Oct. 16, 1984

The Commission has issued the enclosed Amendment No. 7 to Facility Operating License No. NPF-16 for the St. Lucie Plant, Unit No. 2. The amendment adds a license condition and changes the Technical Specifications in response to your application dated March 13, 1984.

AMENDMENT TO FACILITY OPERATING LICENSE

SAFETY EVALUATION BY THE OFFICE OF NUCLEAR REACTOR REGULATION

FIGURE 5.6-1
INITIAL ENRICHMENT VS
BURNUP REQUIREMENTS FOR STORAGE OF
FUEL ASSEMBLIES IN REGION II

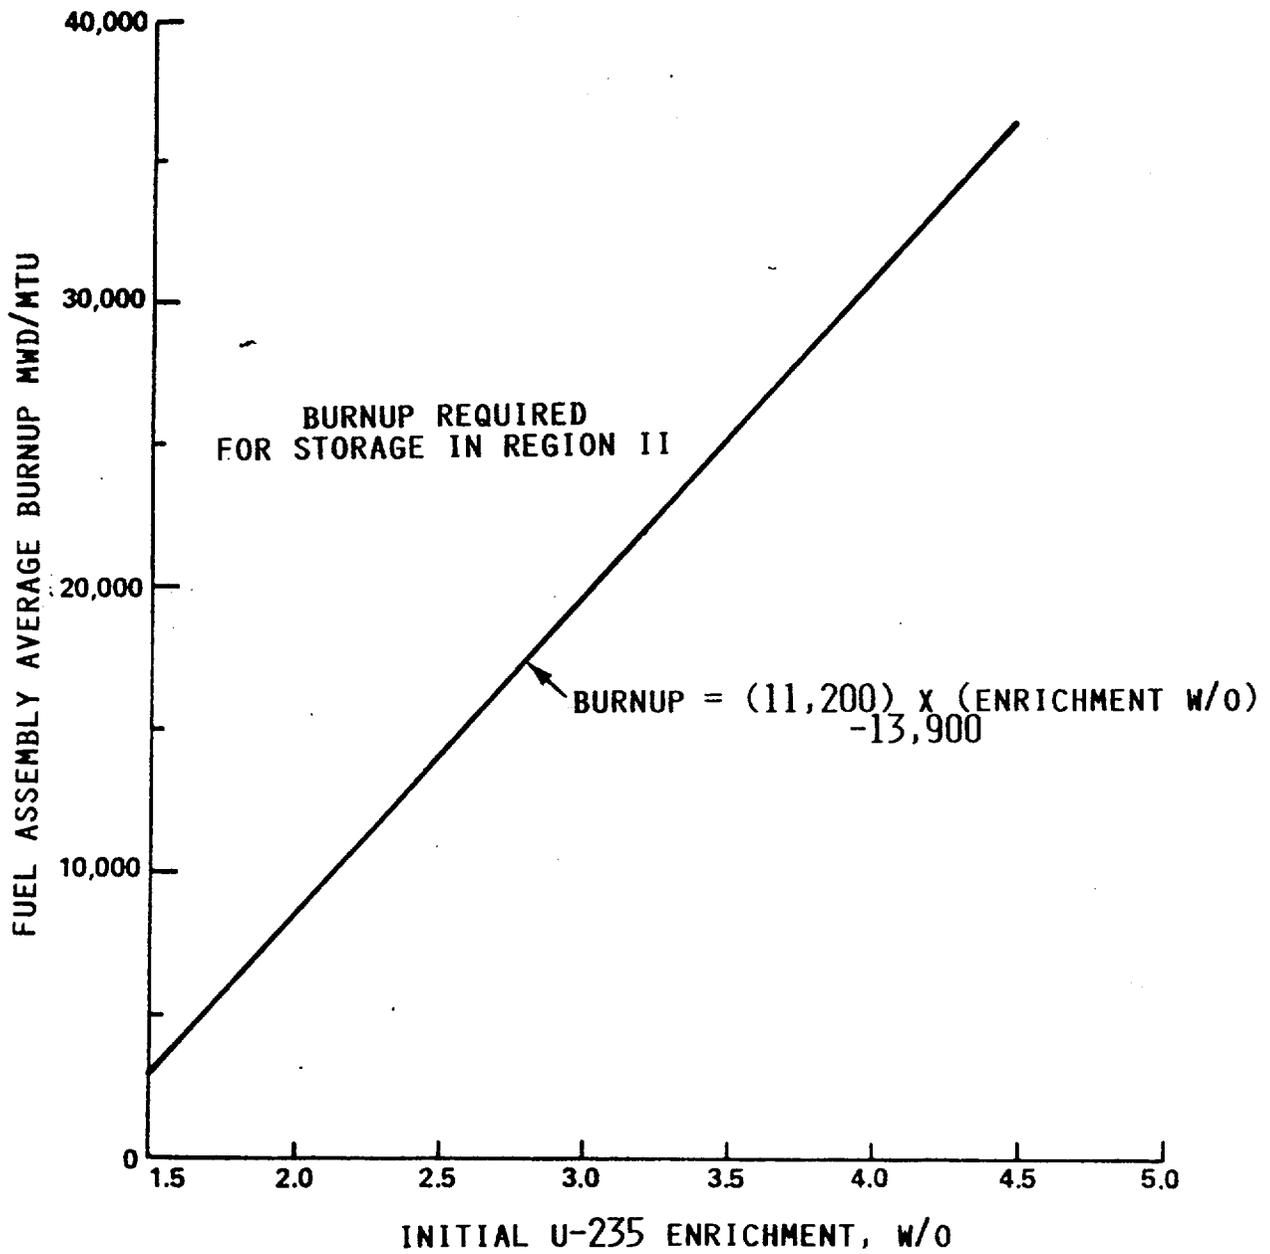
Region I can be used to store fuel which has a U-235 enrichment less than or equal to 4.5 weight percent. Region II can be used to store fuel which has achieved sufficient burnup such that storage in Region I is not required. The initial enrichment vs. burnup requirements of Figure 5.6-1 shall be met prior to storage of fuel assemblies in Region II.
